**RE: Precision Eye Center
7521 Alameda Blvd. NE
Grading & Drainage Plans
Engineer's Stamp Date: 04/19/23
Hydrology File: C19D070**

Re: C19-D070 Responses to Hydrology Comments received on 3/16/2023

**RE: Precision Eye Center
7521 Alameda Blvd. NE
Grading & Drainage Plans
Engineer's Stamp Date: 02/28/23
Hydrology File: C19D070**

GRADING AND DRAINAGE PLAN

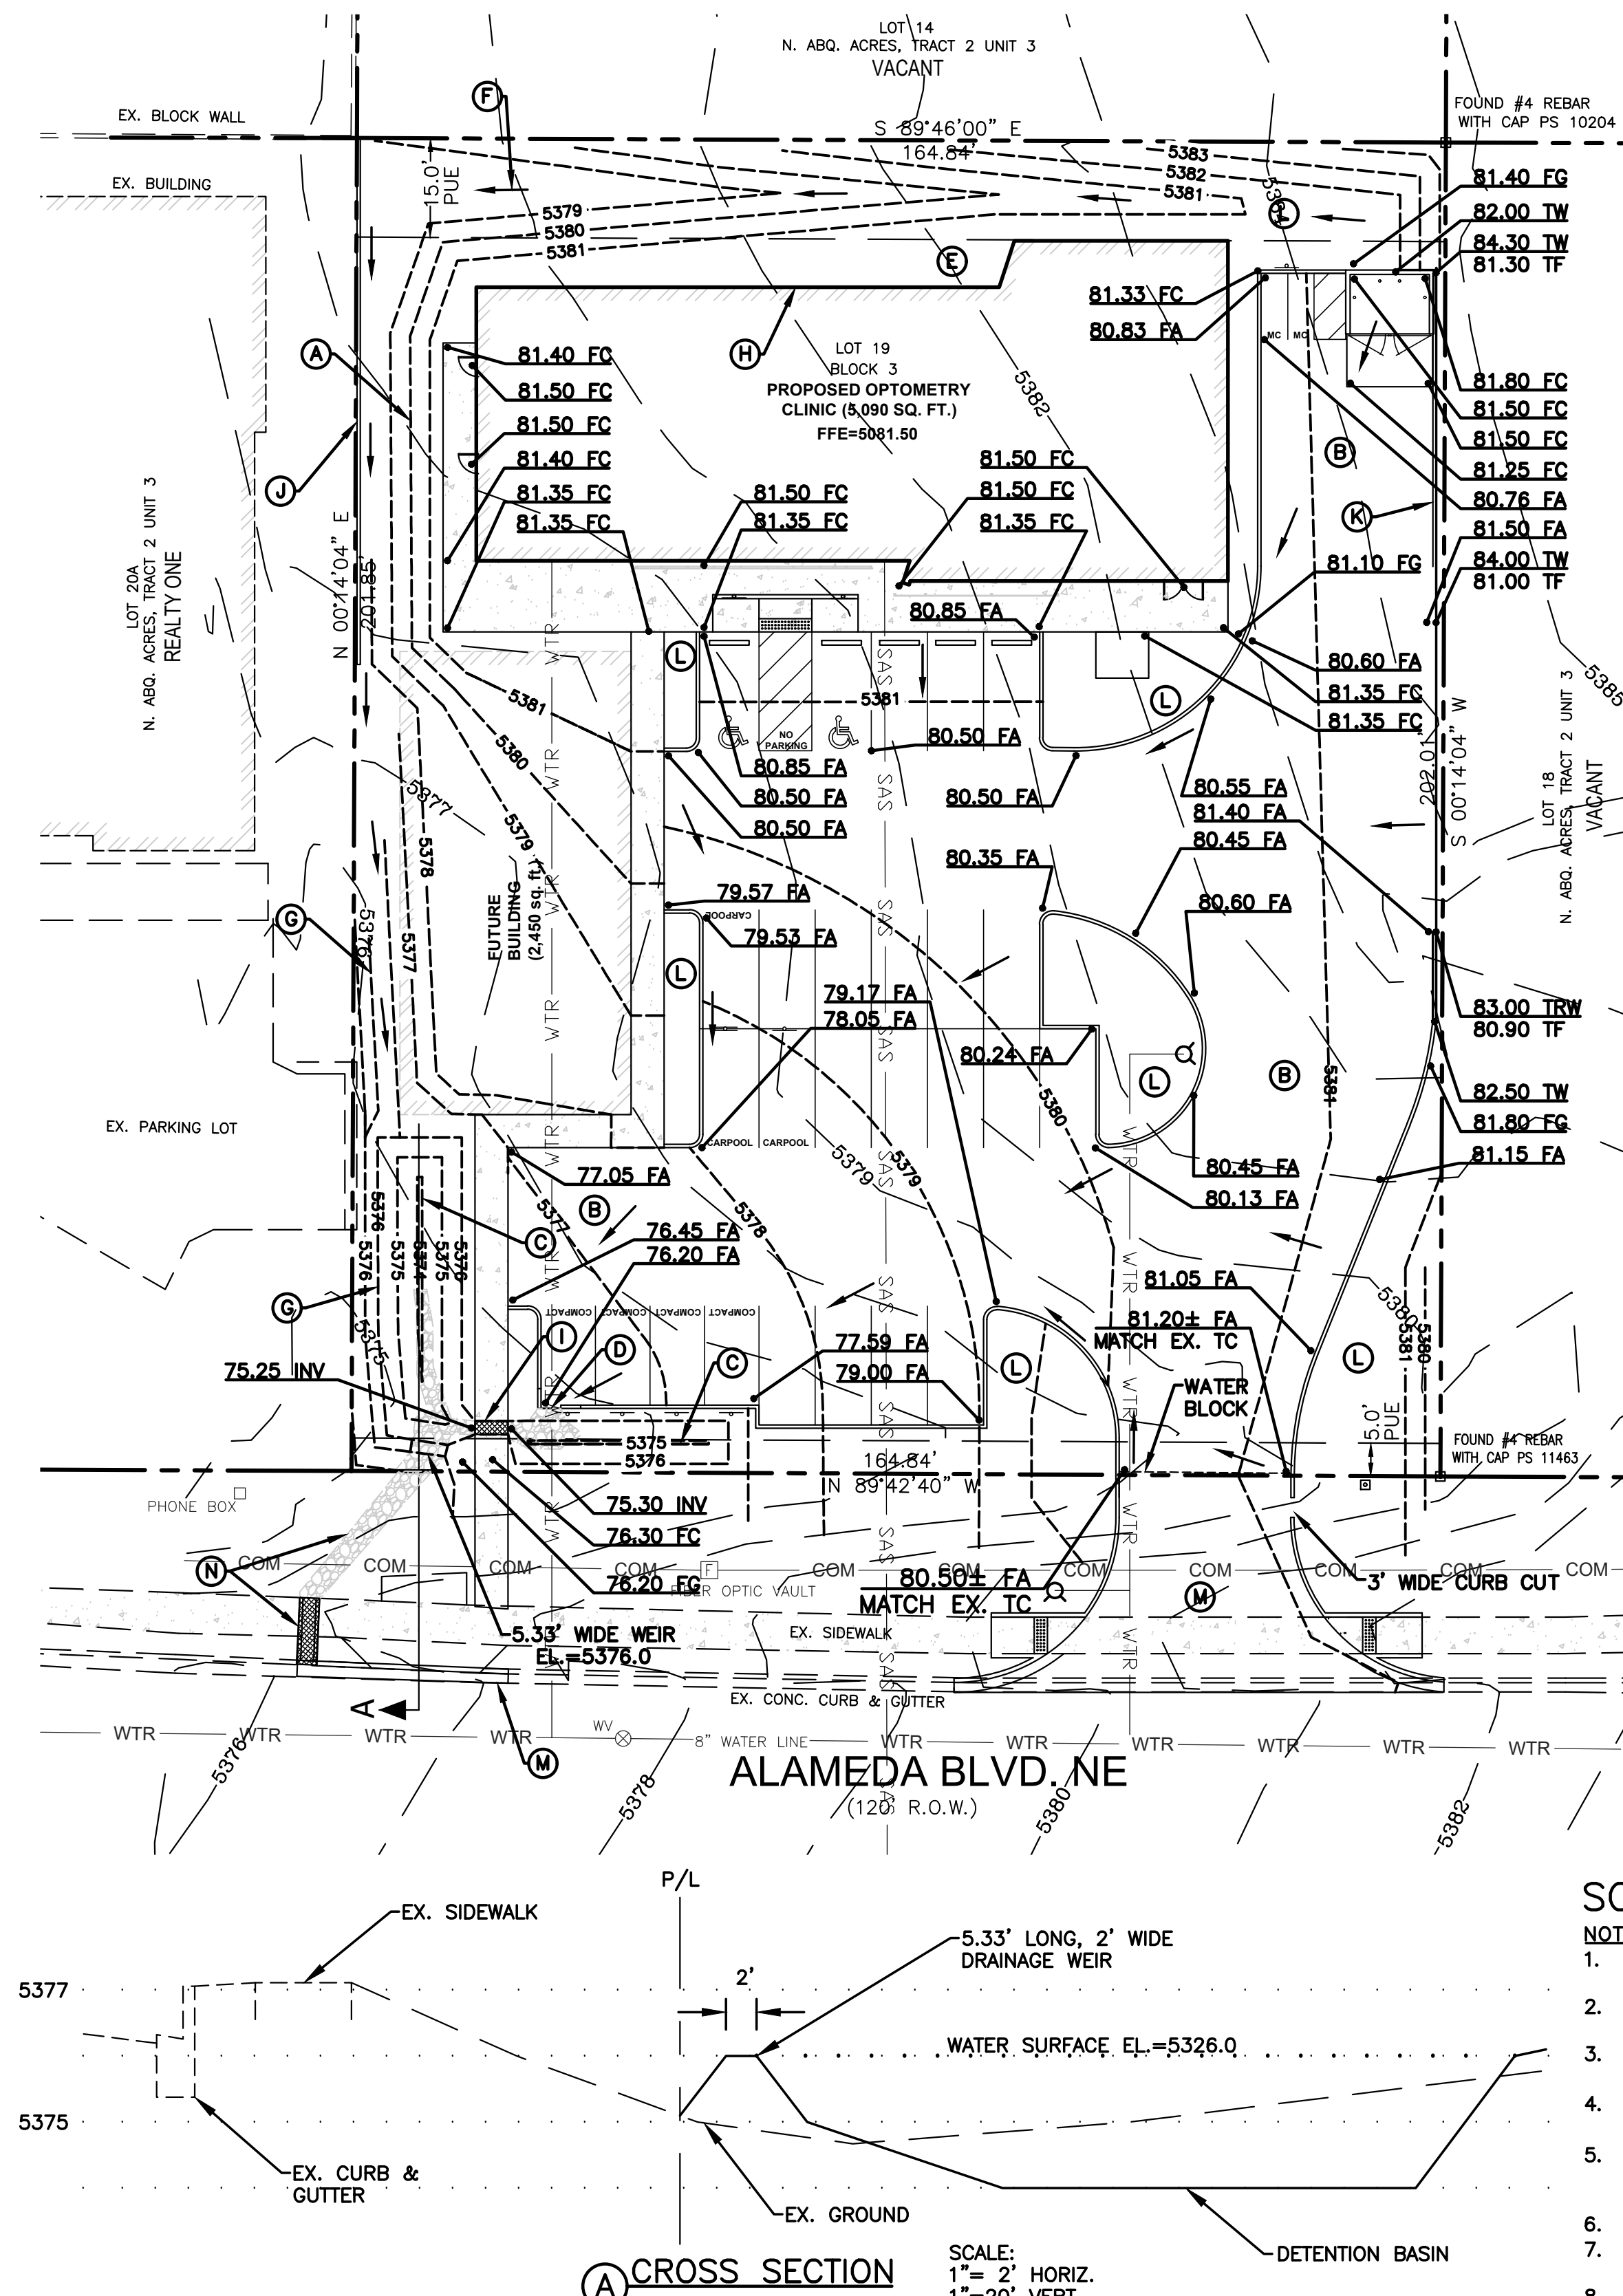
1. Please do not provide Sheets C-001 (Civil Notes), C-101 (Utility Plan), C-301 (Trash Enclosure), and D-101 to D-105 (Civil Details). Hydrology only approves Sheets C-102 (Grading Plan), C-103 (Drainage Plan), and C-201 (Wall Plan & Profile). **relevant details attached**
2. The project curb returns cannot extend beyond the property line. The curb return must become tangent at or before the property line, so please move the entrance about 23 ft to the west. Also, please make the other curb return tangent to the existing curb because it is currently not buildable as shown. **drive pad location adjusted**

3. The existing drive pad at the southwest corner of the property needs to be called out as "Remove existing drive pad and replace with curb & gutter and sidewalk." **work added**

4. On Sheet 103, under the Existing Conditions. Please state, "Project is with North Albuquerque Acres Master Drainage Plan by Resource Technology, Inc. October 1998 which this site has an allowable discharge rate of 3.60 cfs/ac". **added**

5.
when La Cueva Arroyo was placed in a concrete channel, so when the adjacent lot is developed, it will be discharging into Alameda which is reflected in the above NAA Master Drainage Plan. Therefore, accommodating for this is not needed, but any existing flows can be just handled with a curb cut in the curb return to allow the flows to go into Alameda Blvd. So, the curvet that shown does not need to be installed and the grades for the drive needs to follow CoA Detail 2426 with a water block. **curb cut added**

6. On Sheet 103, the Stormwater Quality Pond volume is incorrect. Per DPM Article 6-12 Stormwater Quality and Low-Impact Development for the sizing calculations, 0.42 inches for new development sites and 0.26 inches for redevelopment sites. This site is a new development and not a redevelopment. **SWQV pond and calcs revised using 0.42 in.**

7. On Sheet 102, please provide a sidewalk culvert for the spillway for the stormwater quality pond to Alameda Blvd. and label per CoA Detail 2236. Please also show the invert at the pond (this is the SWQ water surface elevation) and the invert at the existing gutter on Alameda Blvd. **sidewalk culvert with riprap rundown added**

8. On Sheet 103, please provide the weir calculations, per DPM Article 6-16(A), for the curb cuts and sidewalk culverts. A coefficient of 2.7 is typically used for the weir equation $Q = CLH^{2/3}$ **Weir equation added to plan**
9. On Sheet 103, please provide a cross section of the SWQ pond with the bottom of pond elevation, top of pond elevation, and SWQ water surface elevation. **X-section added**
10. On Sheet 102, please provide the Benchmark information (location, description and elevation) for the survey contour information provided. **Benchmark info. added**
11. On Sheet 102, please provide the SO-19 Standard Notes, latest version. **added**
